CITY PLAN COMMISSION**THURSDAY, MARCH 21, 2024****FILE NUMBER:** S234-064**SENIOR PLANNER:** Sharmila Shrestha**LOCATION:** bounded by Forest Cliff Drive, Greenmeadow Drive, John West Road, and Lakeland Drive**DATE FILED:** February 21, 2024**ZONING:** PD 674**PD LINK:** [Microsoft Word - Article 674.doc \(dallascityhall.com\)](#)**CITY COUNCIL DISTRICT:** 7**SIZE OF REQUEST:** 10.737-acres**APPLICANT/OWNER:** Dallas Independent School District**REQUEST:** An application to create one 10.737-acre lot from a tract of land in City Blocks 7295 and 7390 to create one lot on property bounded by Forest Cliff Drive, Greenmeadow Drive, John West Road, and Lakeland Drive.**SUBDIVISION HISTORY:** There has been no recent platting activity within close proximity to this request.**STAFF RECOMMENDATION:** The request complies with the requirements of PD 674; therefore, staff recommends approval of the request subject to compliance with the following conditions:**General Conditions:**

PRE JANUARY PLAT
S.S. CONNER ELEMENTARY
SCHOOL ADDITION
LOT 1, BLOCK #7285
BRING A PART OF CITY BLOCK 7285 AND CITY BLOCK 7293
BEING OUT OF THE JOHN DANIEL SINGER, ABSTRACT NO. 402
OF THE CITY OF CHICAGO, ILLINOIS
CITY PLAT FILE NO. 5234-064
FEBRUARY 20, 1924

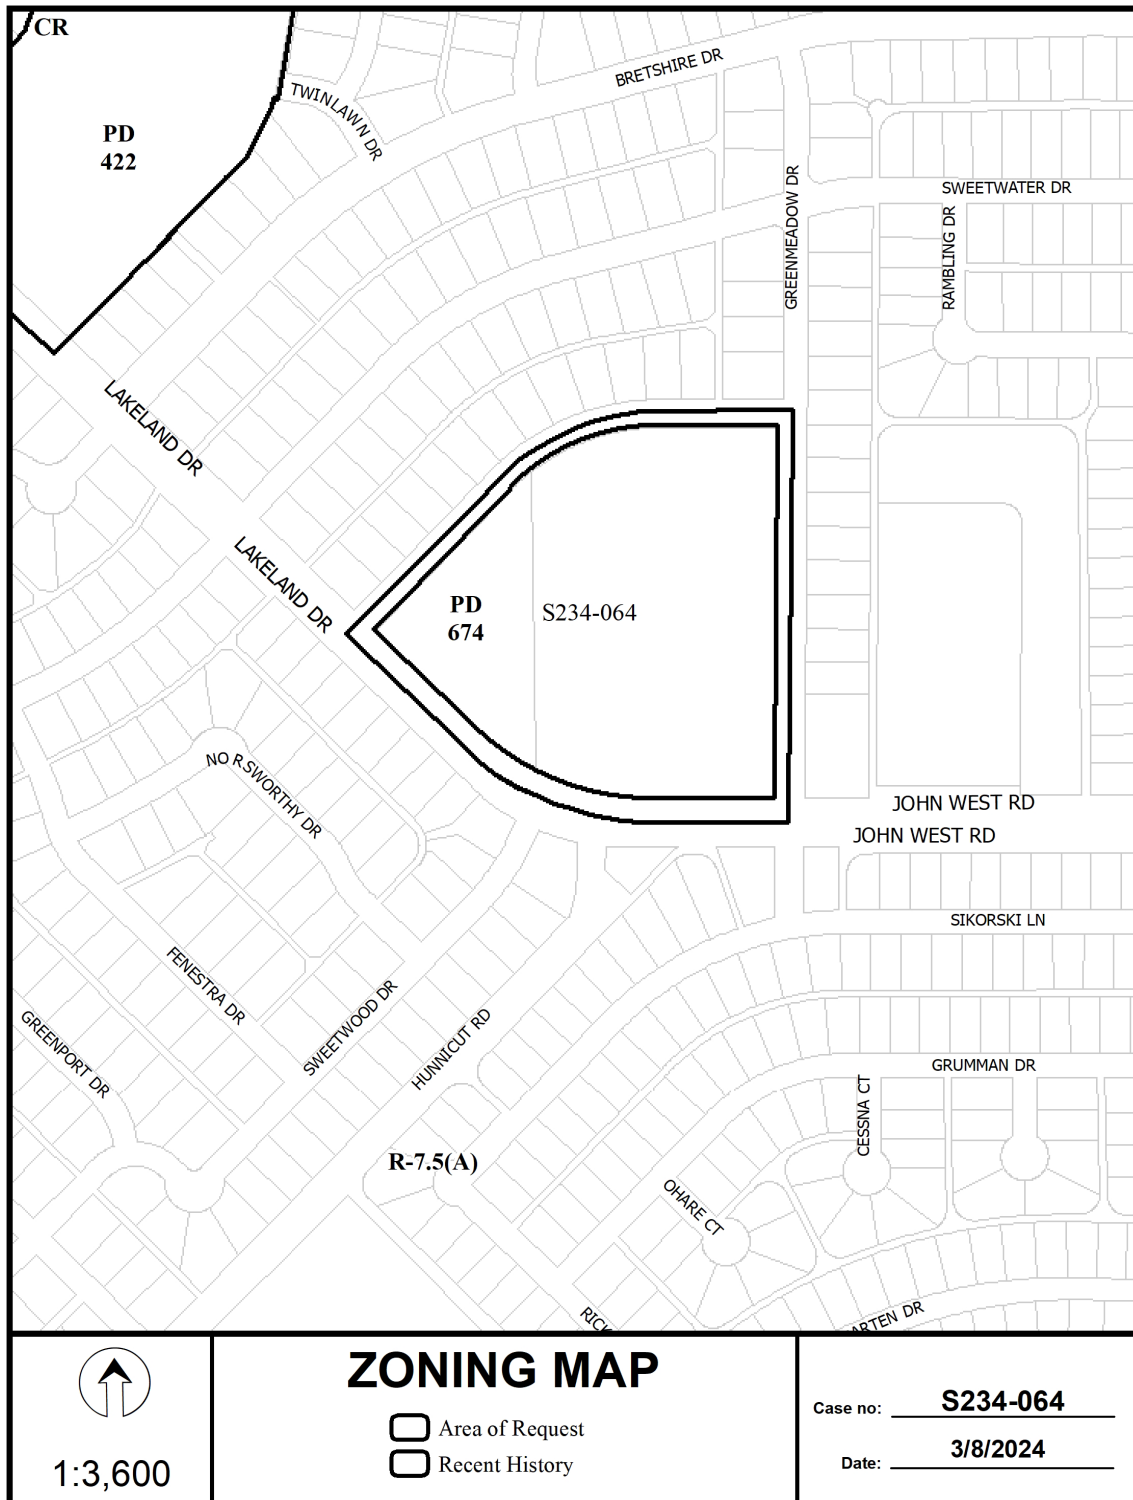
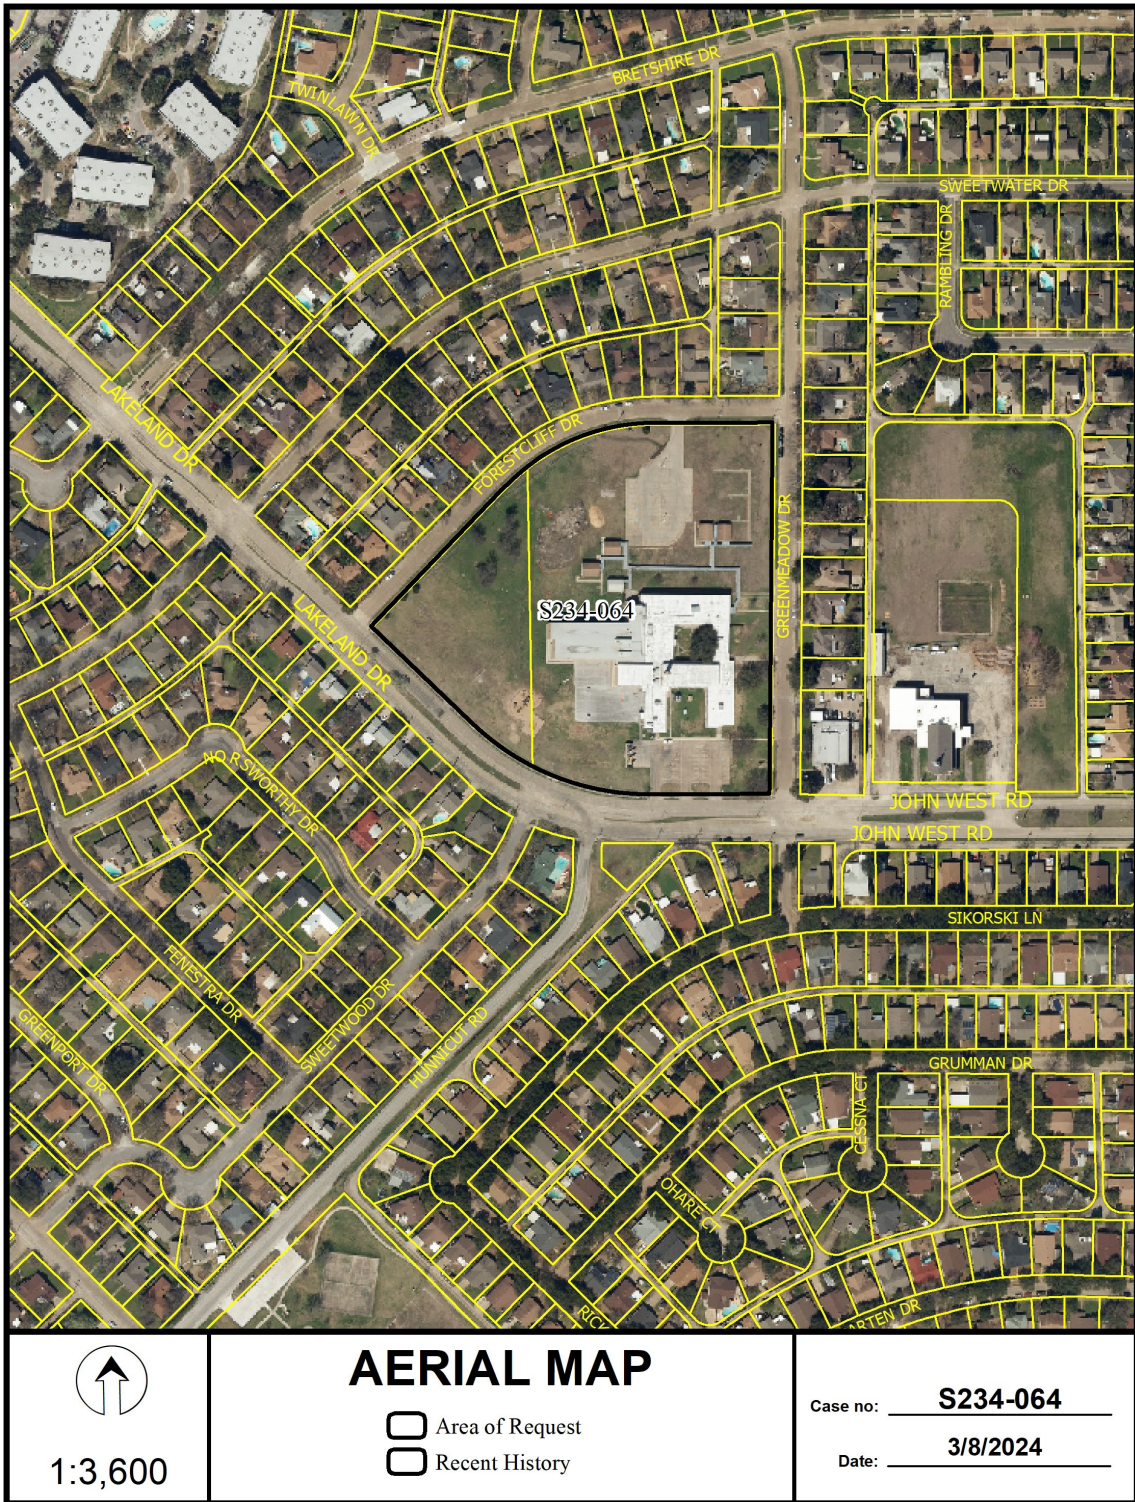
15. On the final plat, dedicate a minimum 5-foot by 5-foot corner clip (via fee simple or street easement) at the intersection of Lakeland Drive and Forest Cliff Drive. Section 51A 8.602(d)(1)
16. On the final plat, dedicate a minimum 5-foot by 5-foot corner clip (via fee simple or street easement) at the intersection of John West Road and Green Meadow Drive. Section 51A 8.602(d)(1)
17. On the final plat, dedicate a minimum 5-foot by 5-foot corner clip (via fee simple or street easement) at the intersection of Green Meadow Drive and Forest Cliff Drive. Section 51A 8.602(d)(1)
18. A larger corner clip may be requested during engineering plan and traffic review to accommodate an adequate turning radius, or to maintain public/traffic appurtenances, within the area of the corner clip. *Section 51A 8.602(d)(1), 51A 8.608(a)*

21. Prior to final plat, submit a completed final plat checklist and all supporting documents.
22. On the final plat, show recording information on all existing easements within 150 feet of the property.
23. On the final plat, show all additions or tracts of land within 150 feet of the property with recording information.

27. On the final plat, change “Lakeland Drive” to “Lakeland Drive (FKA John West Road)”.
28. On the final plat, change “Hunnicut Road” to “Hunnicut Road (FKA Cox Road)”.
29. On the final plat, identify the property as Lot 1 in City Block A/7390.
